Groundwater Transfer Review Summary Form

Transfer/PA # T- 14867

Application: T-14867

Applicant Name: Joseph D. Worden & Alma D. Worden

Figure 2: Hydrograph

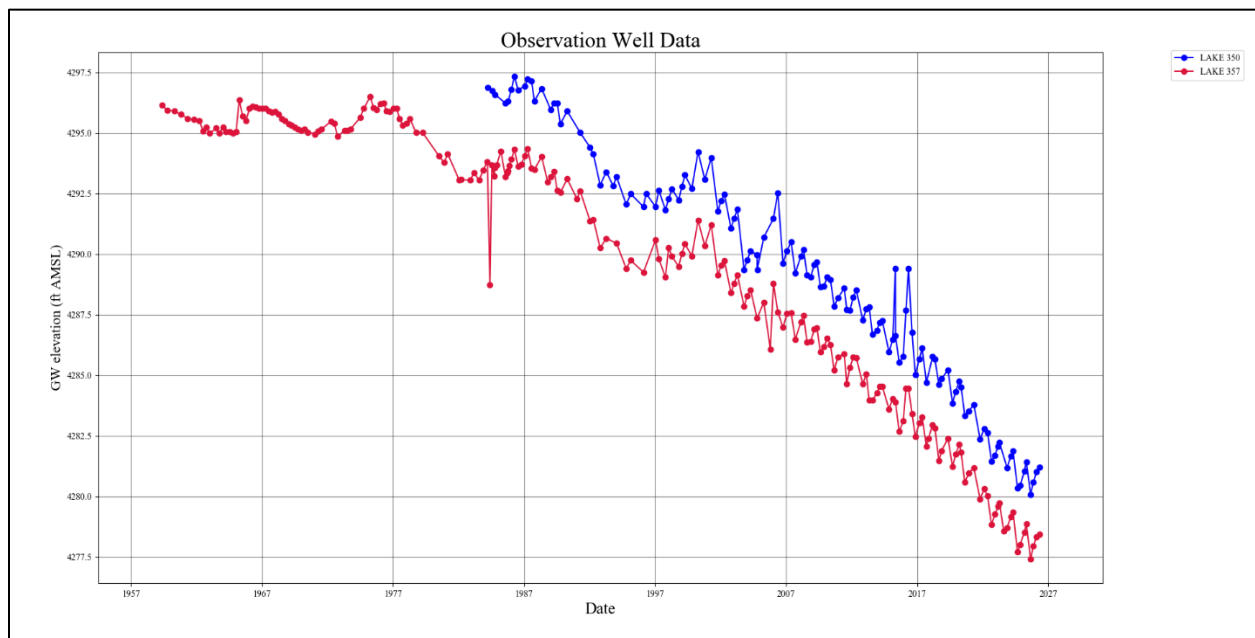
3. a) Is the existing authorized POA subject to a water level decline condition?
☐ Yes ☒ No Comments: No decline conditions associated with Certificate 41331, but a hydrograph is provided as Figure 2 at the end of the document.

LAKE 350 has had consistent measurements since 1984 and shows a decline of approximately 0.57 ft/ year since May 2006. LAKE 357 is a nearby state observation well that tracks with LAKE 350 and has a longer period of record that begins in 1959.

Figure 3: Theis Drawdown

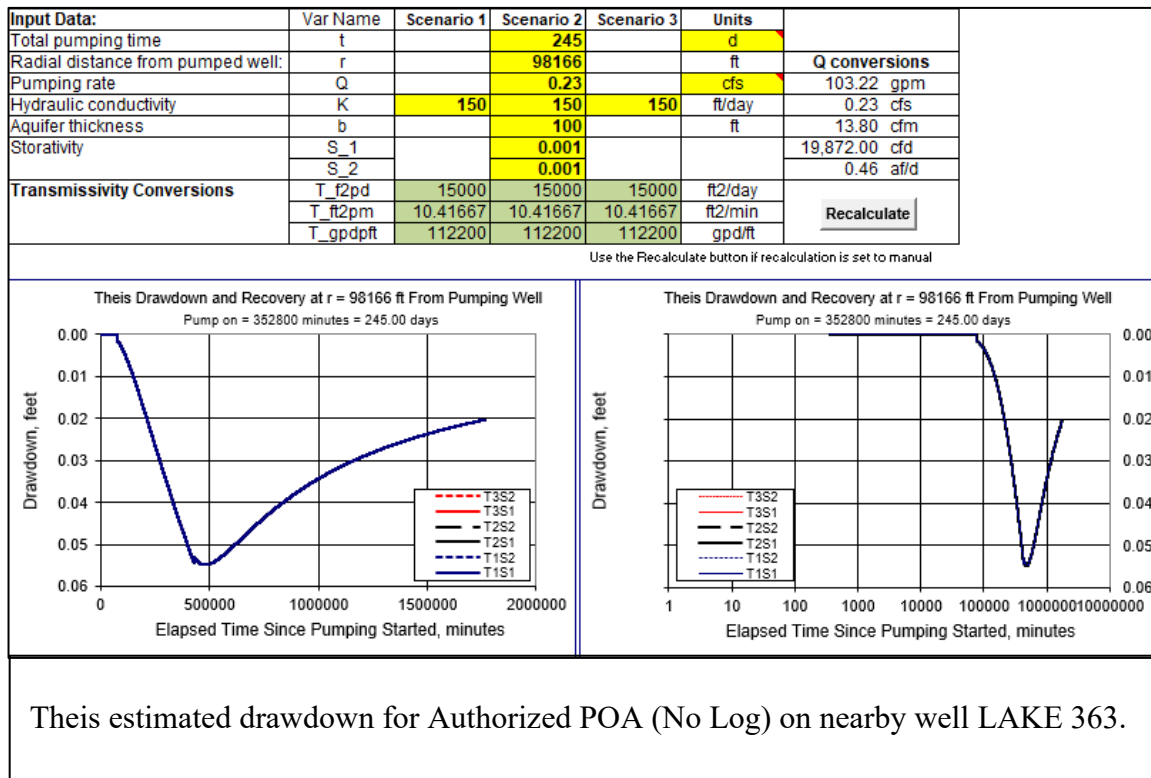
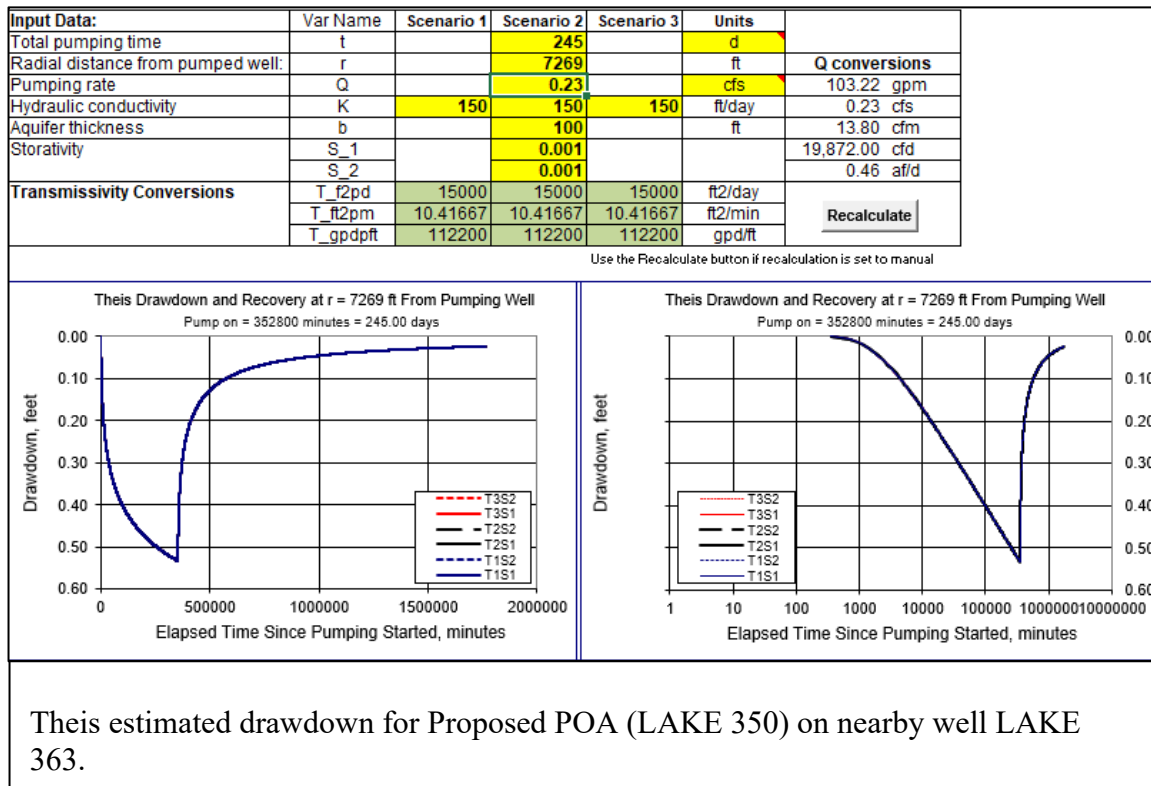
5. a) Will this proposed change, at its maximum allowed rate of use, likely result in an increase in interference with **another ground water right**?
☒ Yes ☐ No Comments: Proposed POA is moving 7269 ft away from LAKE 363, which is an irrigation well that is a POA for certificates 92359 and 98008.

- b) If yes, would this proposed change, at its maximum allowed rate of use, likely result in another groundwater right not receiving the water to which it is legally entitled?
☐ Yes ☒ No If yes, explain: A Theis drawdown analysis was performed for this proposed change in POA using an intermediate storage coefficient of 0.001, transmissivity estimate of 15,000 ft²/day from McFarland and Ryals (1991), and a maximum pumping rate of 0.23 CFS for a duration of 245 days. Considering pumping from both the proposed POA and the affected well, the estimated increase in drawdown from the proposed POA is 0.48 ft for a max drawdown of 3.13 ft. This increase in drawdown would not meet the standard of "substantial or undue interference". The Theis drawdown analysis is included as Figure 3.
